HISTORIC AND DESIGN REVIEW COMMISSION

HDRC CASE NO: 2021-475
ADDRESS: 901 MASON ST
LEGAL DESCRIPTION: NCB 1267 BLK 3 LOT S 137.0 OF 9 & 10 & N 50.0 OF E 24.0 FT OF 9 ARB 9C, 10A, & 9B
ZONING: O-2, H
CITY COUNCIL DIST.: 2
DISTRICT: Government Hill Historic District
LANDMARK: Individual Landmark
APPLICANT: robert miranda/finesse construction llc
OWNER: logan fullmer/901 MASON LLC
TYPE OF WORK: Installation of a standing seam metal roof with a ridge cap
APPLICATION RECEIVED: September 03, 2021
60-DAY REVIEW: Not applicable due to City Council Emergency Orders
CASE MANAGER: Edward Hall
REQUEST:

The applicant is requesting a Certificate of Appropriateness for approval to install a standing seam metal roof with a ridge cap on the historic structure at 901 Mason, located within the Dignowity Hill Historic District.

Checklist for Metal Roofs

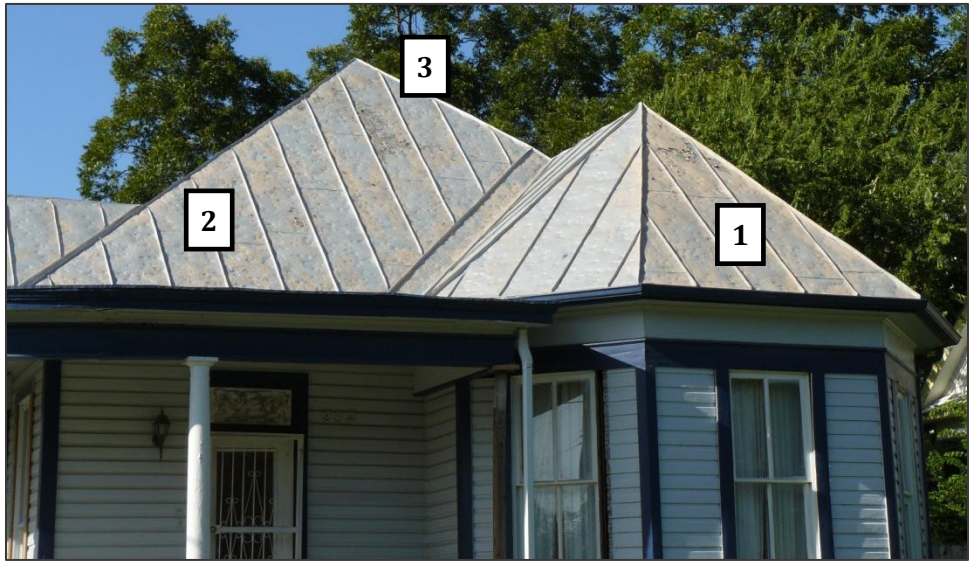
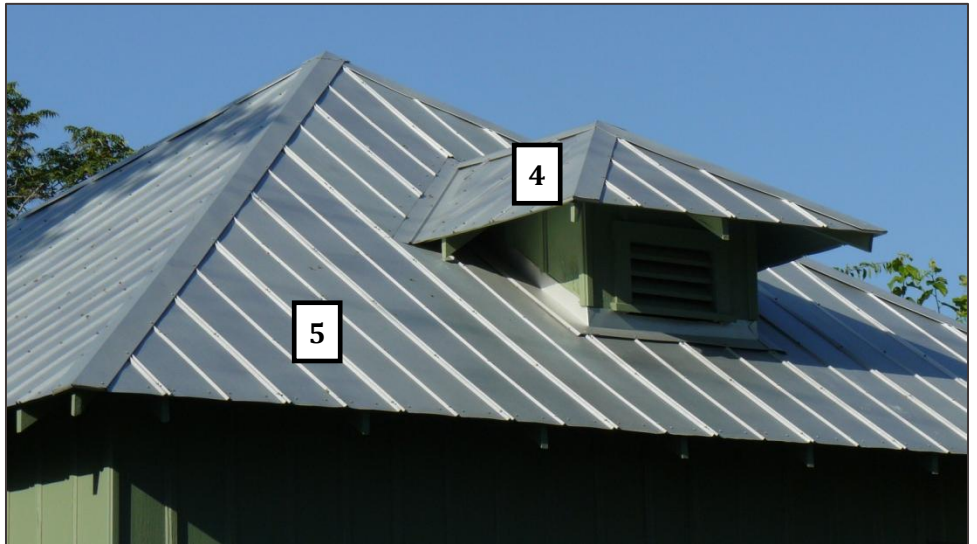
- 1** Use panels that are 18 to 21 inches in width.
- 2** Ensure seams are an appropriate height for the slope of the roof (1 to 2 inches).
- 3** Use a crimped ridge seam that is consistent with the historic application.
- 4** Use a low-profile ridge cap with no ridge cap vent or end cap when a crimped ridge seam is not used.
- 5** Match the existing historic roof color or use the standard galvalume; modern manufacturer's colors are not recommended.

Do not use ridge caps with ridge cap vent (left) or end caps (right).
